#### SOAH DOCKET NO. 473-23-21216 PUC DOCKET NO. 55067

APPLICATION OF ONCOR
ELECTRIC DELIVERY COMPANY
LLC TO AMEND ITS CERTIFICATE
OF CONVENIENCE AND
NECESSITY FOR THE RAMHORN
HILL TO DUNHAM 345 KV
TRANSMISSION LINE IN DENTON
AND WISE COUNTIES

## RESPONSE OF ONCOR ELECTRIC DELIVERY COMPANY LLC TO GRBK EDGEWOOD LLC AND GBTM SENDERA, LLC'S FIRST REQUEST FOR INFORMATION

DOCKET 55067ATTACHMENT NO. 1 TO GRBK AND GBTM RFI SET NO. 1 QUESTION NO. 1-02 PAGE 1 OF 1

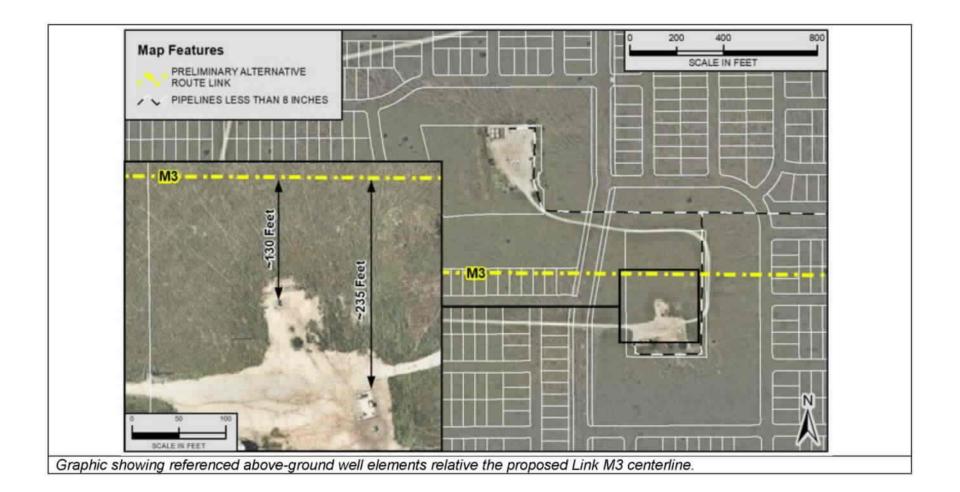
Please refer to page 24 of the rebuttal testimony of Russell Marusak. Please provide any and all associated environmental data for route segments M3, including any impediment identified by Oncor or Halff to constructing M3 as proposed that was not previously known at the time that segment was originally proposed by Oncor.

Please refer to Oncor's response to DCLC RFI 1-3, which includes environmental data for Link M3 and modified versions of Link M3 as provided by DCLC.

Halff identified several oil and gas wells on properties now understood to be the GRBK/GBTM properties. Link M3 crosses what has been identified by as the GRBK/GBTM permitted well area. Historical aerial imagery shows that the well was constructed between 1990-1995. No evidence of disturbance or prior facilities extended into the filed Link M3 alignment. Attachment 1 shows approximate distances of above-ground facilities relative to the filed Link M3 alignment.
